30347 RESOLUTION

Certificates of Appropriateness for work in the Historic Districts:

HISTORIC ARCHITECTURAL REVIEW BOARD CITY OF ALLENTOWN

November 1, 2021 FINAL REVIEW

Property located at: 301 N 9th St.

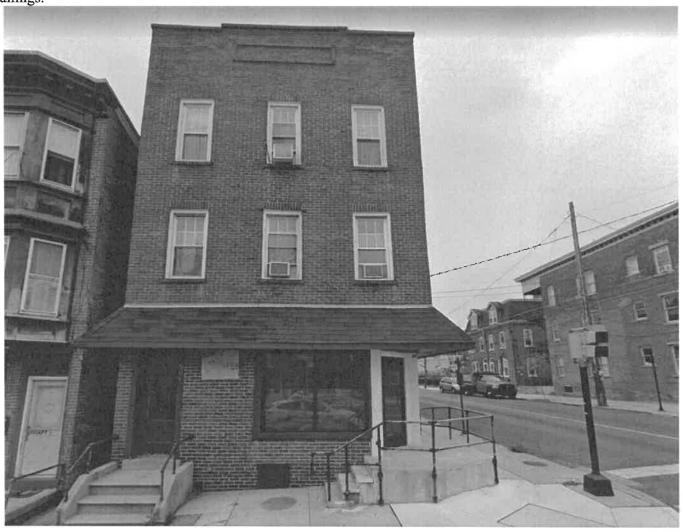
The proposed signage consists of two window signs placed on the storefront windows, one at each façade, and one at the door. The proposed location of exterior security camera(s) was not indicated in the application. The storefront materials are not original, and it is not architecturally distinctive, therefore the proposed signage will not negatively impact historic fabric. The proposed window signs are applied lettering and the business' logo with a high amount of transparency, which can reduce the overall impact of the bright color proposed.

HARB suggested painting the security cameras and wiring to blend better with the surrounding architecture.

It is recommended that the applicant indicate the proposed location(s) and number of exterior security cameras that are part of the application. It is generally recommended to reduce the visibility of exterior equipment as much as possible.

A motion to approve the application as proposed with the recommendation that the security camera and wiring be painted to match the soffit was made by HARB member Ellen Roberts, motion was seconded by HARB member Michelle Olson. Motion carried with unanimous support.
